U.S. Army Corps
of Engineers
Seattle District

Skagit Flood Risk Management Working Group

Presentation by Ron Malmgren
9/14/2000

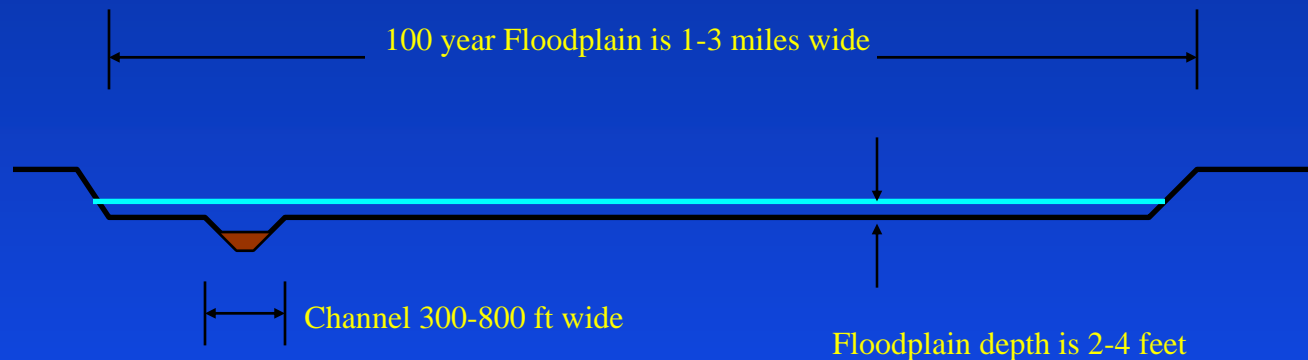
- Dredging the mouth of the river is a very popular belief. Can you simulate the effects of dredging there to demonstrate whether or not it will help? Is there a project there that would help move sediment farther out into the bay?

Dredging the mouths of the North and south Forks will not reduce the flooding on the main stem. There might be limited localized benefits during low tide in the lower reaches of the North and South Forks but the main stem will not see these benefits due to limited channel capacity.

The river needs to be dredged to convey 100,000 cfs of water that now will flow in the floodplain 2 miles wide by 3 feet deep at over 3 fps. The channel will need to be dredged 10-20 ft deep to convey this additional water.
